**SUBJECT: THE UNIVERSITY OF WISCONSIN - ISSUANCE OF AMENDMENT NO. 18 TO  
FACILITY LICENSE NO. R-74 TO REVISE THE ORGANIZATIONAL  
STRUCTURE IN THE TECHNICAL SPECIFICATIONS FOR THE UNIVERSITY  
OF WISCONSIN NUCLEAR REACTOR (EPID NO. L-2020-NFA-0007)**

Amendment No. 18  
License No. R-74

SAFETY EVALUATION BY THE OFFICE OF NUCLEAR REACTOR REGULATION

**Figure TS-1, Organization Chart**

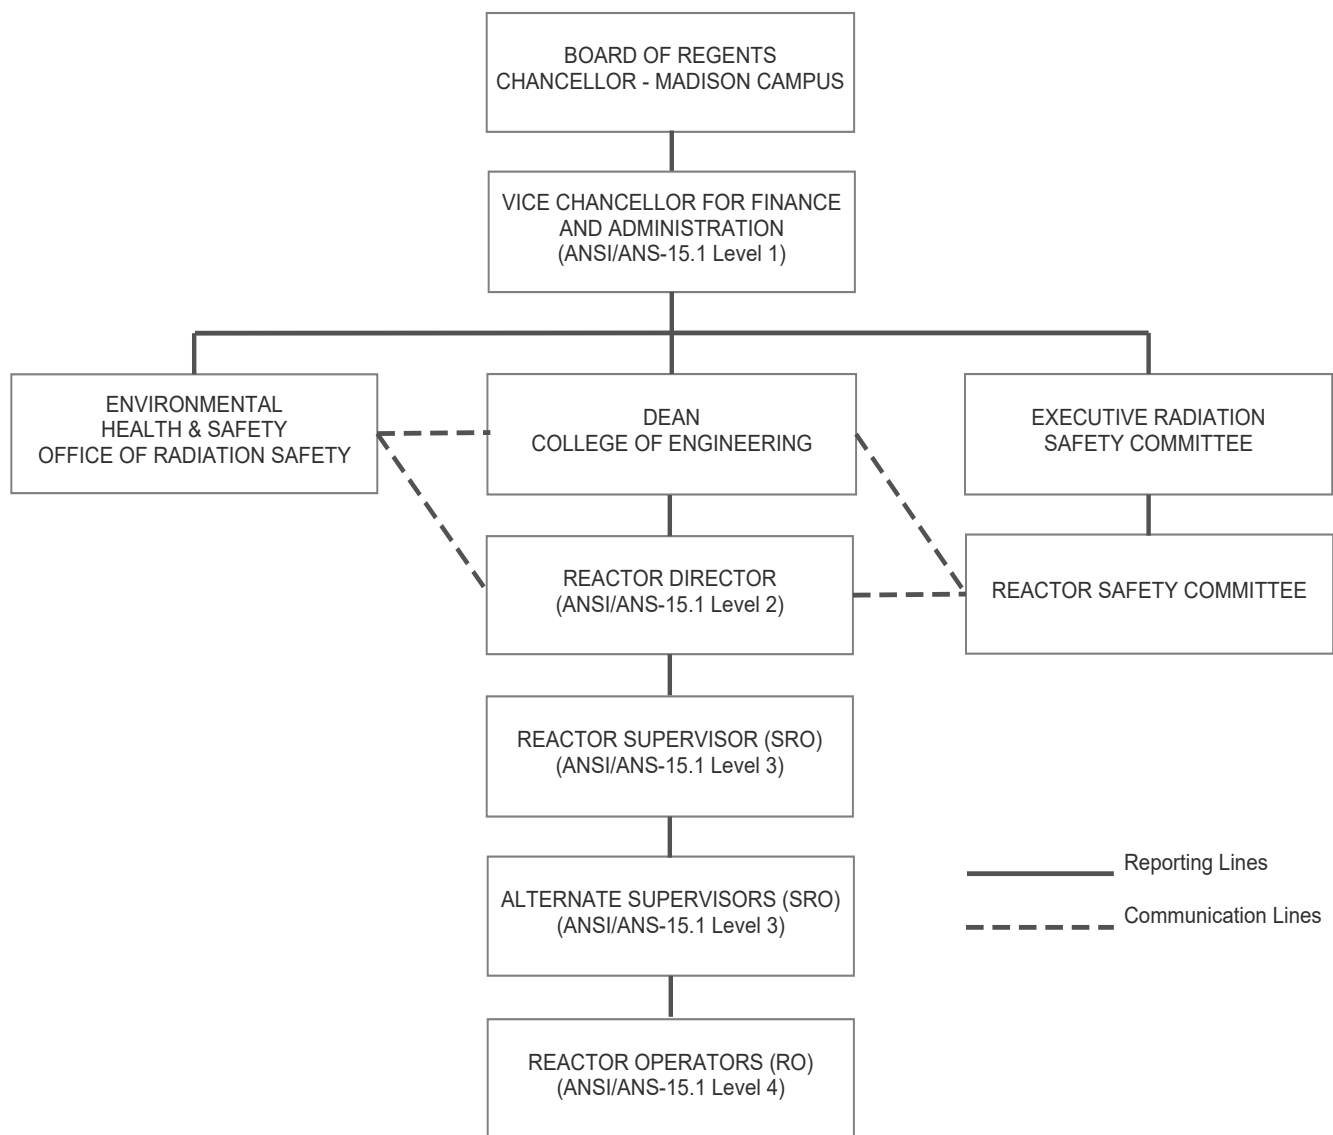
The license is held by the Board of Regents of the University of Wisconsin System. The Board of Regents delegates operations of the Madison campus to the Chancellor. The Chancellor delegates management of the reactor to the Vice Chancellor for Finance and Administration. The reactor facility shall be an integral part of the College of Engineering of the University of Wisconsin-Madison. The reactor shall be related to the University structure as shown in **Figure TS-1**.

### 3.1.3 Technical Specification Figure TS-1, "Organization Chart"

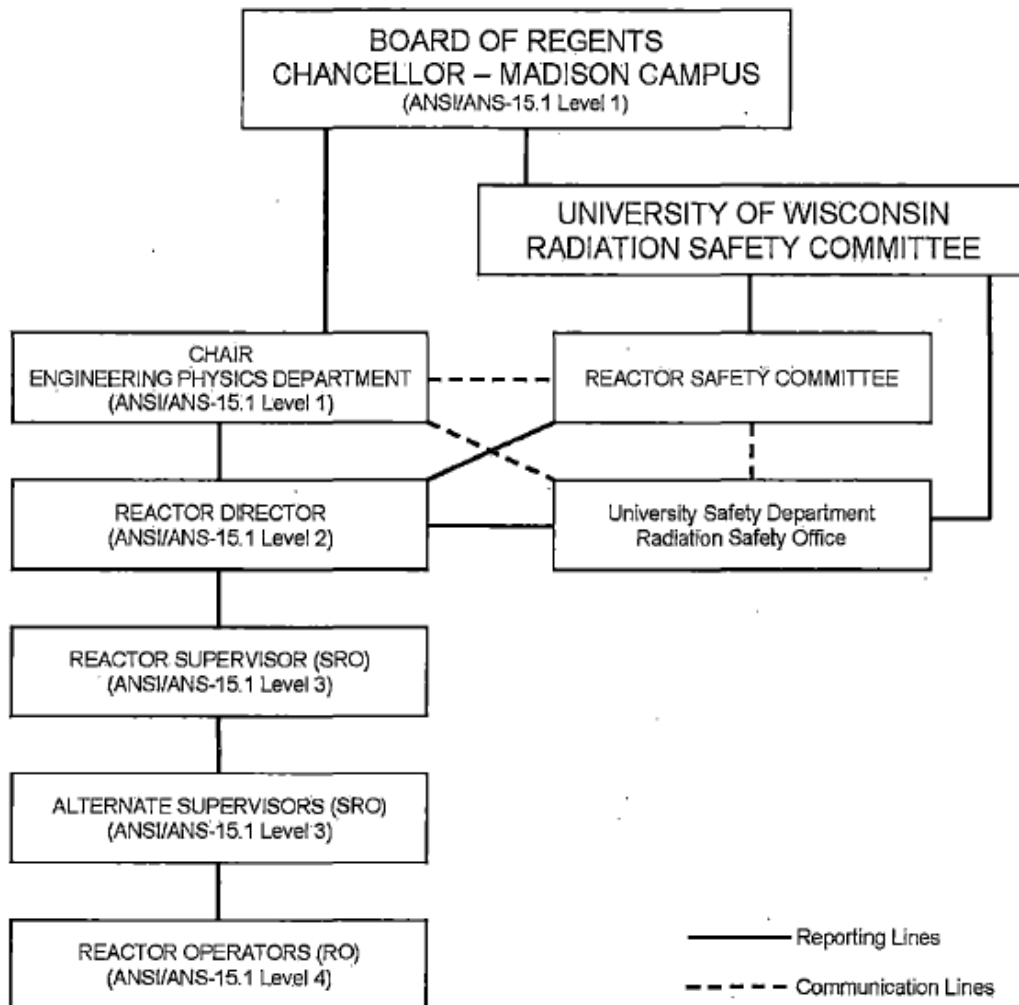
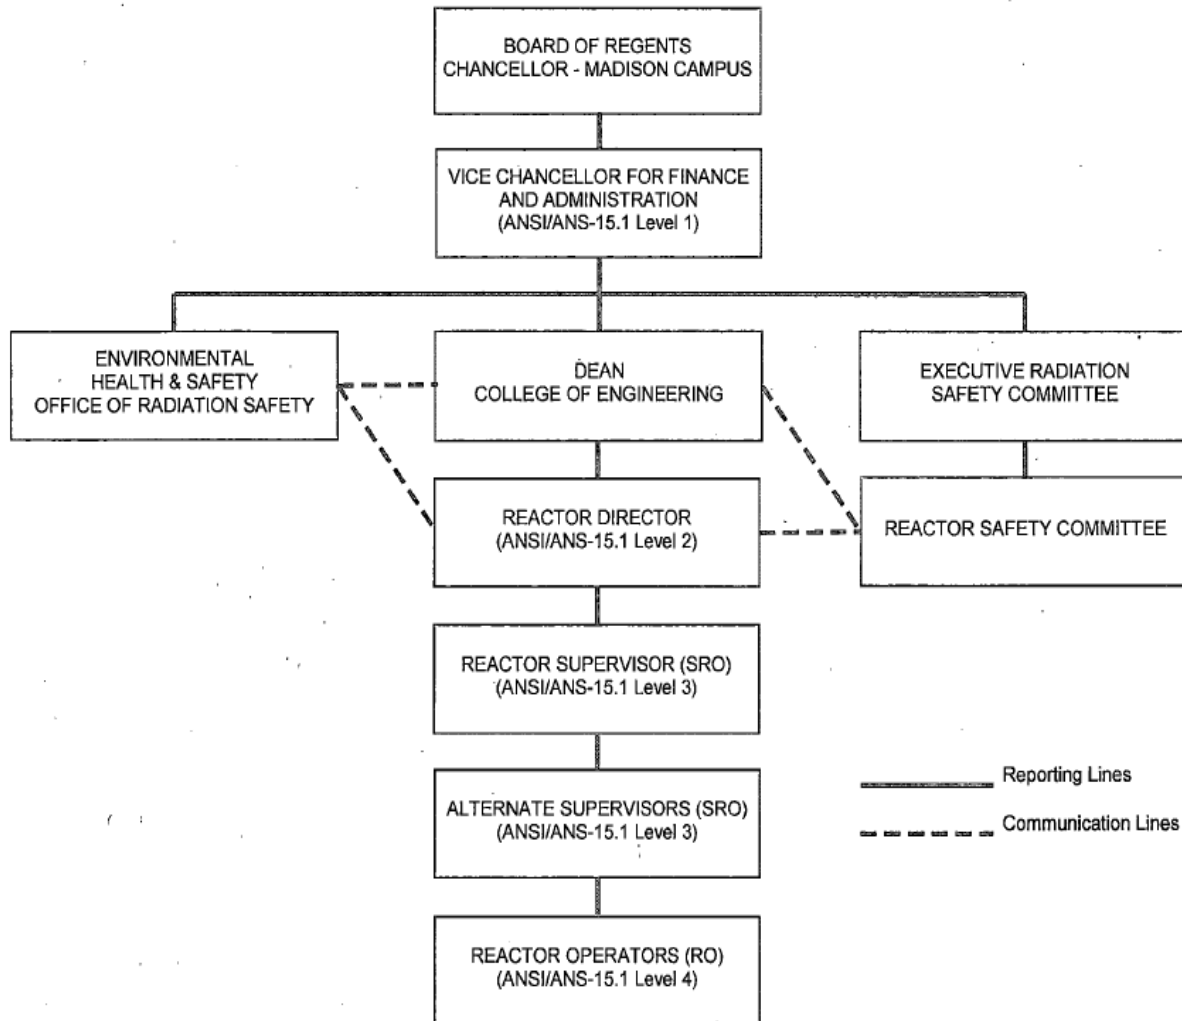
The licensee proposed to update TS Figure TS-1 to replace the Chair of the Engineering Physics Department with the Vice Chancellor for Finance and Administration and insert the Dean of the College of Engineering. Further, the licensee indicated that the proposed updated TS Figure TS-1 clearly identifies the structure of the review and audit groups (the Reactor Safety Committee and the ORS), as well as their reporting lines to Level 1 management and communication lines to Level 2 management, consistent with the guidance provided in ANSI/ANS 15.1-2007, Section 6.1.1.

The current TS Figure TS-1 is:

The proposed TS Figure TS-1 (which would replace the current TS Figure TS-1 in its entirety) is:

The NRC staff reviewed the proposed TS Figure TS-1 and finds that it is consistent with the guidance in ANSI/ANS 15.1-2007, Section 6.1.1, as it provides the structure of the review and audit groups, as well as their reporting and communication lines to Levels 1 and 2. The NRC staff finds that the proposed changes are also consistent with the proposed TS changes described in Section 3.1.1 of this safety evaluation, and that the proposed TS Figure TS-1 is acceptable.
